BE IT REMEMBERED THAT THE CLINTON COUNTY DRAINAGE BOARD
MET IN REGULAR SESSION ON JUNE 3, 2025
AT 10:15A.M.

WEST PLAIN MINOR PLAT – PROPOSED 1-LOT SUBDIVISION – DRAINAGE REVIEW:

HARDY HILLS SOLAR FARM – DRAINAGE ISSUES: Mr. Sheets informed the Board that he has been working with a representative for Hardy Hills to resolve some drainage issues in and around the solar farm. Mr. Sheets stated that they have proposed solutions to the drainage issues in power blocks 29 and 36.

BRANT-TALBERT-WALKER WATERSHED – CLINTON CENTRAL HIGH SCHOOL – NEW PARKING LOT – DRAINAGE REVIEW: Mr. Sheets informed the Board that a drainage plan for the Clinton Central High School parking lot expansion has been submitted for review by krM Architecture. Mr. Sheets stated that the new parking lot will be located northwest of the high school.

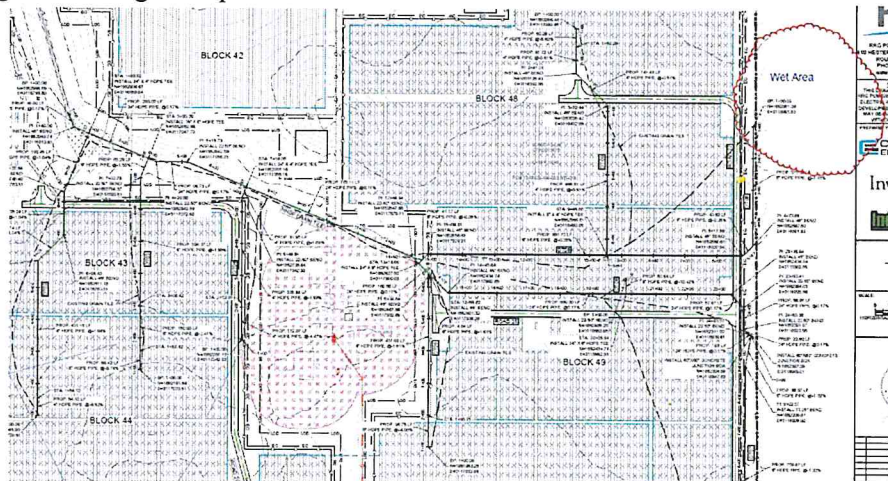
Mr. Sheets stated that the proposed solution to the drainage issue in power block 29 includes installing a six-inch perforated single wall drain tile with filter sock and three six-inch laterals with hickenbottom risers at the end of each. He then stated that the tile will connect to Branch #3 of the Elmer Slipher regulated drain. Mr. Sheets informed the Board that he does not object to the proposal.

Mr. Sheets stated that the proposed solution to the drainage issue in power block 36 includes installing a riser to an existing private tile on the north side of County Road 300 North, west of County Road 50 East.

Mr. Sheets recommended approving the proposed solutions to power blocks 29 and 36. Mr. Myers made a motion to approve the solutions, seconded by Mr. Weaver. Motion carried 3-0.

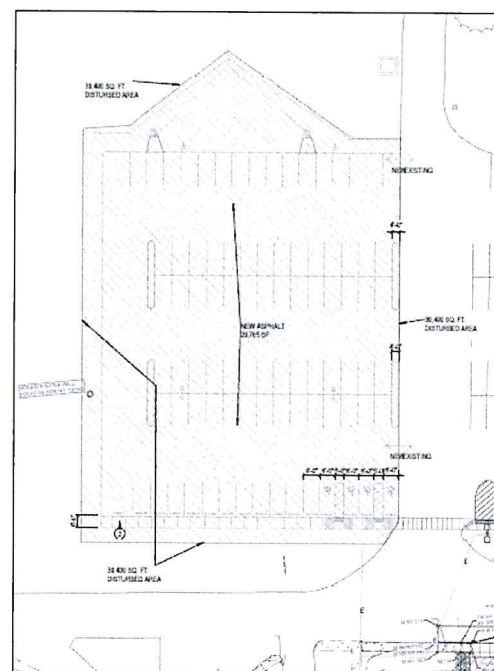
Mr. Sheets stated that the new lot will surface drain to the northwest corner of the property to a 15" RCP that runs under County Road 100 North and outlets into the D. Power Open Ditch within the Brant-Talbert-Walker Watershed. Mr. Sheets stated that the runoff will travel through an existing swale in the yard that will slow it down and mitigate any flooding in the area. Mr. Sheets then stated that this is a relatively small parking area and he recommends granting drainage approval. Mr. Myers made a motion to grant drainage approval to the Clinton Central High School parking lot expansion, seconded by Mr. Weaver. Motion carried 3-0.

③ SITE PLAN DISTURBED SOIL AREA
SCALE: 1" = 30'

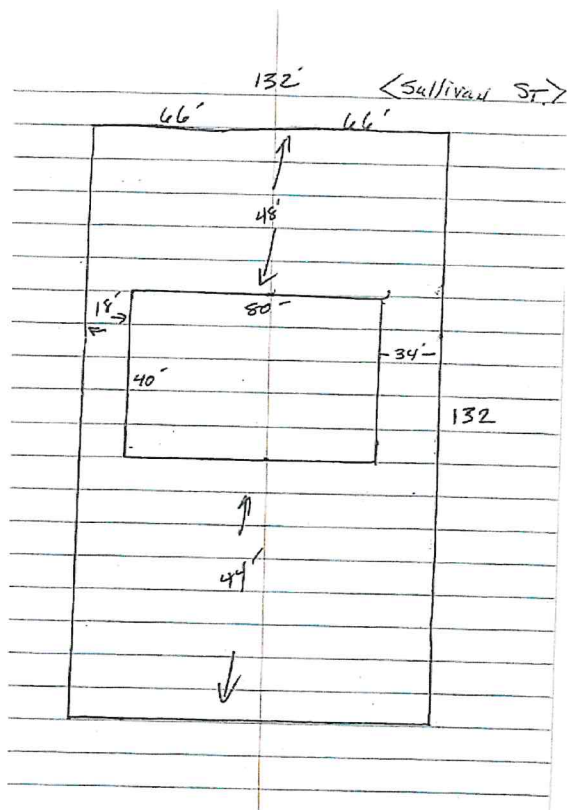
SOUTH EIGHTH STREET: Mr. Sheets informed the Board that several weeks ago the owner of the property at the intersection of Eighth Street and Sullivan Street was granted a variance to build on their site. Mr. Sheets stated that according to the site plan submitted the structure would be forty-four feet from the south property line. Mr. Sheets then stated that the Aughe drain is located just south of the south property. Mr. Sheets further stated that a portion of the foundation has been installed, and it is only 30-feet from the south property line and 38-feet from the Aughe drain. Mr. Sheets then stated that he is willing to issue another variance if the Board agrees since there is still plenty of room to maintain the tile, and the new structure is still farther away than the old house was. Mr. Weaver made a motion to grant a variance reducing the Aughe legal drain right-of-way to 38-feet at 700 S Eighth Street, seconded by Mr. Myers. Motion carried 3-0. Mr. Sheets then informed the Board that the foundation has been installed too low to

700 S Eighth Street

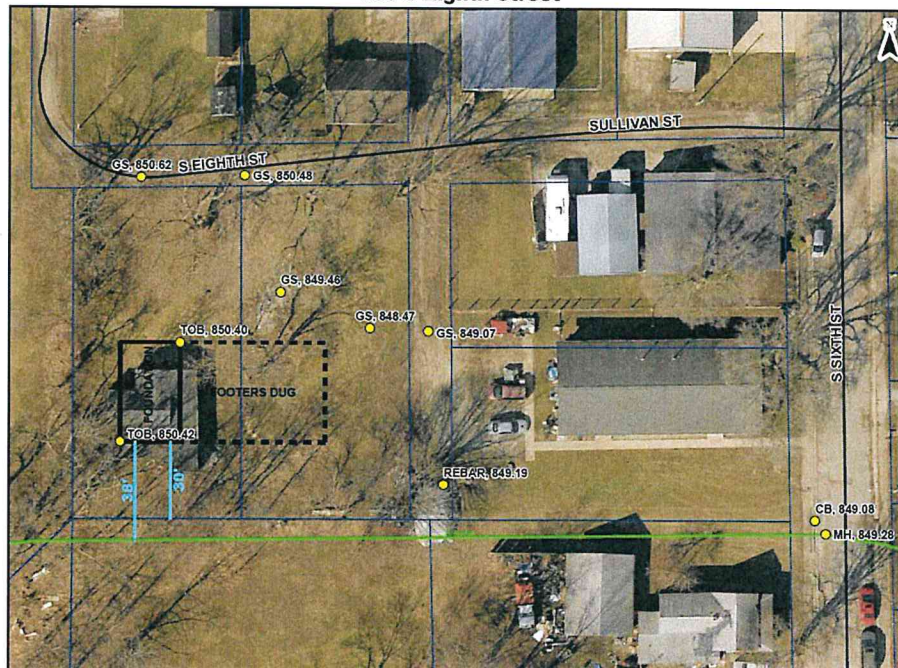
meet the building code for drainage away from the building. Mr. Sheets stated that typically even though it is the City's jurisdiction the Surveyor's Office will check finished floor elevations within the City of Frankfort, however, we were not contacted to check the elevation on this home before construction began. Mr. Sheets then stated that he will be meeting with the City building inspector later today to discuss the issue.
